# AKAI SERVICE MANUAL

EXTERNAL SRAM BOARD

MODEL **SXM007** S/X

SXM007S/X  
SCHEMATIC DIAGRAM  
NO. 880201A

003 Subject: Trouble countermeasure

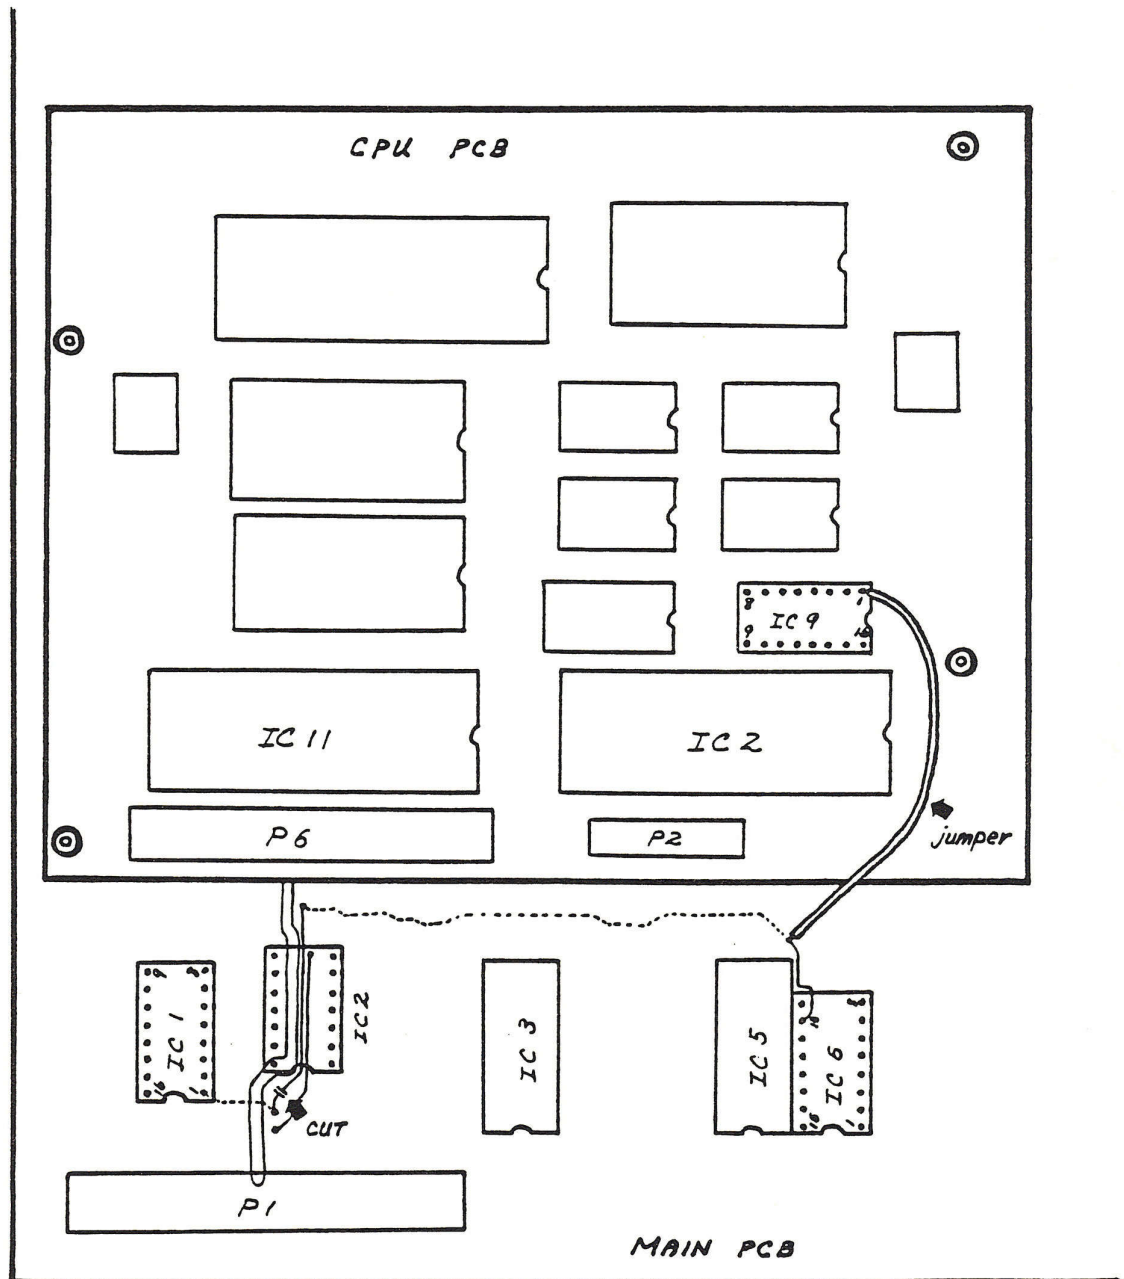
Symptom : Sample sound may become noisy after hours of use.

Remedy : Change Pin10 connection of IC6 in Main P.C. Board to get Clock signal from Pin1 of IC9 in CPU P.C. Board. Cut a P.C.B. pattern and add a jumper wire as shown.

Note : The Main P.C. Board with this modification is not interchangeable and will not work correctly when installed to an old unit without a jumper wire to CPU P.C. Board.

005 Subject: Trouble countermeasure

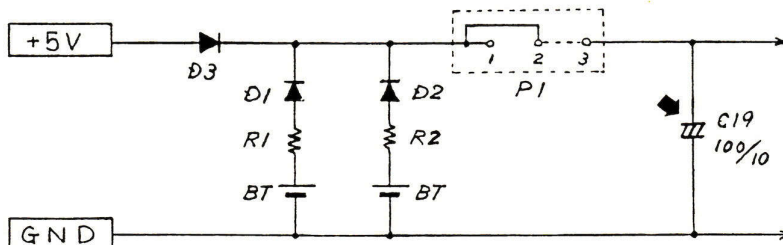
Symptom: 1) Noise may be produced when Sample memorized is played with SXM007-S installed.  
2) "Verify Error" may appear when verified after S700 is turned off and turned on again with SXM007-S installed.

Cause : Momentary drop in Power Supply voltage of SRAM board when S700 is turned off.

Remedy : Install additional C19 tantalum capacitor(100uF/10V) in Power Supply Line.

|       | Ref. No. | Part No.   | Description            |
|-------|----------|------------|------------------------|
| (NEW) | 2-C19z   | EC-385802J | C TT V S99 101M 10.0DC |

## 005 Subject: Trouble countermeasure

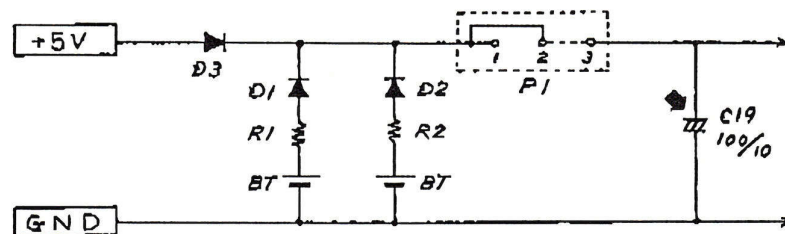
Symptom: 1) Noise may be produced when Sample memorized is played with SXM007-X installed.  
 2) "Verify Error" may appear when verified after X7000 is turned off and turned on again with SXM007-X installed.

Cause : Momentary drop in Power Supply voltage of SRAM board when X7000 is turned off.

Remedy : Install additional C19 tantalum capacitor(100uF/10V) in Power Supply Line.

|       | Ref. No. | Part No.   | Description            |
|-------|----------|------------|------------------------|
| (NEW) | 2-C19z   | EC-385802J | C TT V S99 101M 10.0DC |
